## 777 - Piper

Fin Front Spar Modification.

PA-30 Twin Comanche  
PA-39 Twin Comanche "C/R"

**FIGURE 1**

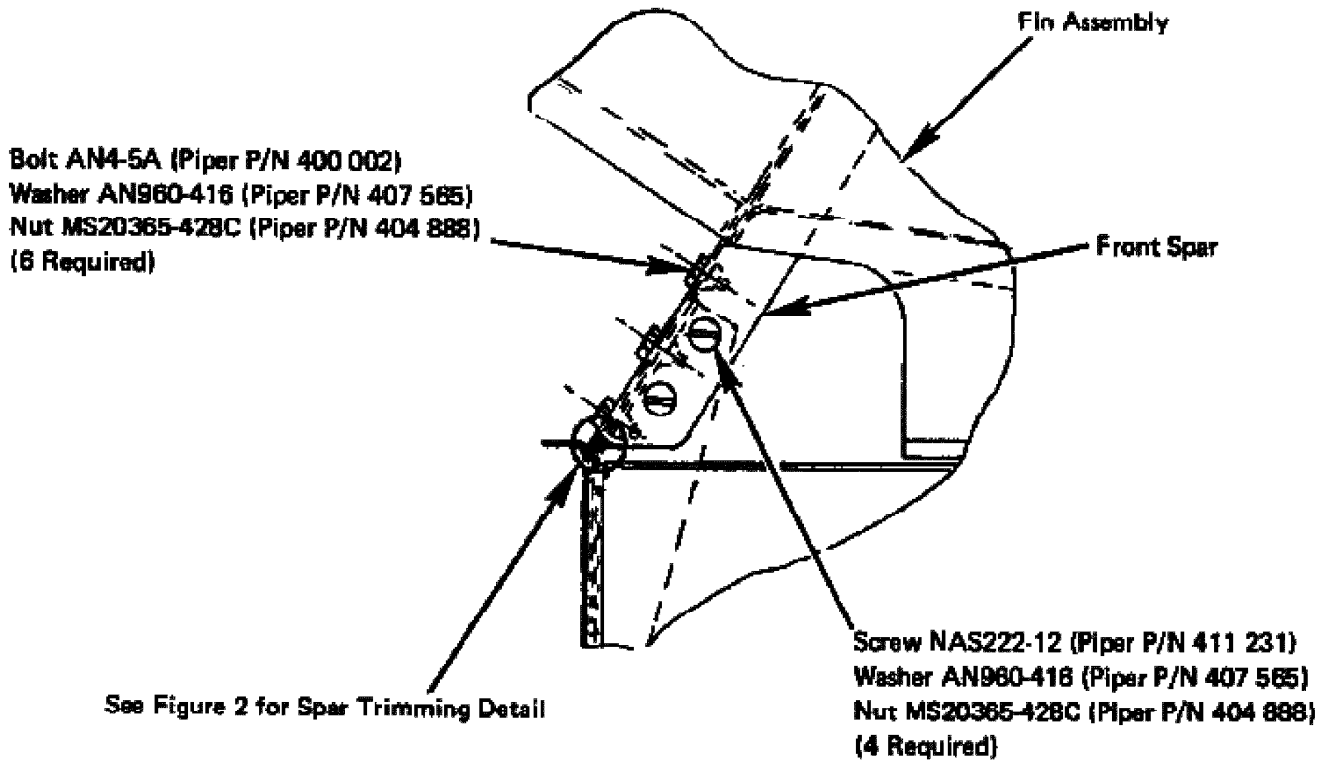
FAA Airworthiness Directives #75-12-06 dated June 5, 1976 required a repetitive inspection of the PA-24 Comanche series Fin Front Spar to Fuselage Attachment Channel bend relief holes for evidence of cracks; repair or replace cracked channels/ straps if cracks are detected . . . etc. We have been advised that, in the near future, the FAA is planning a similar action relative to the PA-30 and PA-39 Twin Comanche series.

**FIGURE 2**  
**(SPAR TRIMMING DETAIL)**

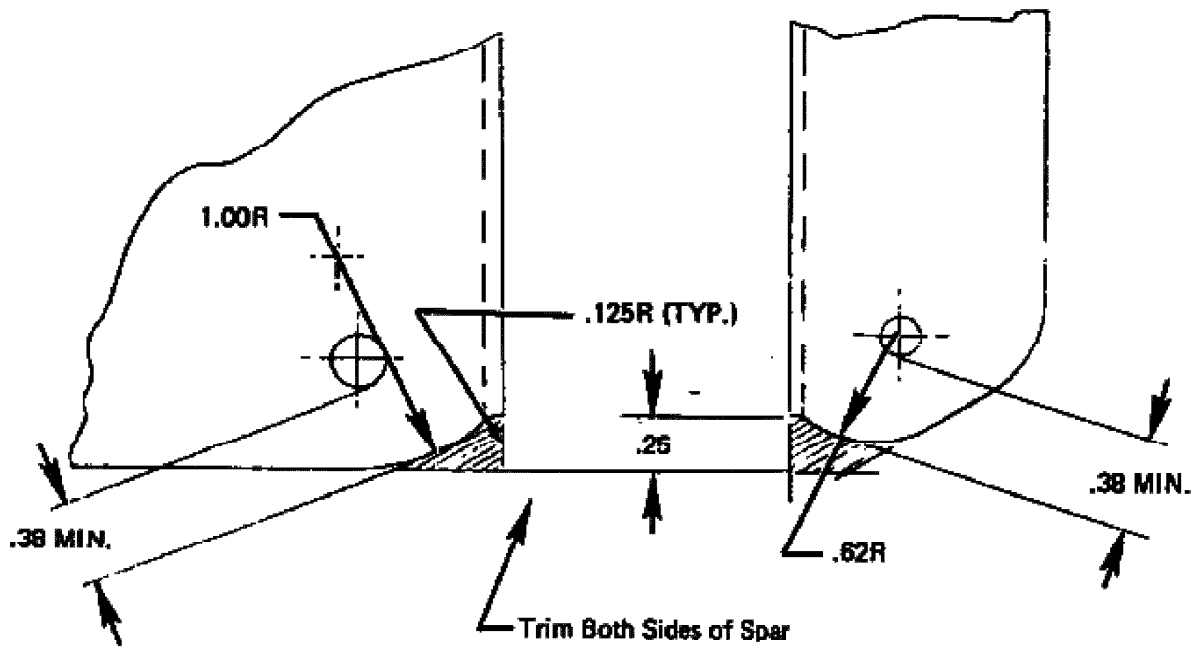
Since it is necessary to physically remove the Fin Assembly to gain visual access to the channel relief holes (as the Fin Front Spar extends over the relief holes diameter), this service release provides instructions to modify the Fin Front Spar to eliminate repetitive removal of the fin and to enable an easy visual inspection.

Refer to "Spar Trimming Detail" Instructions on reverse side of this service release.
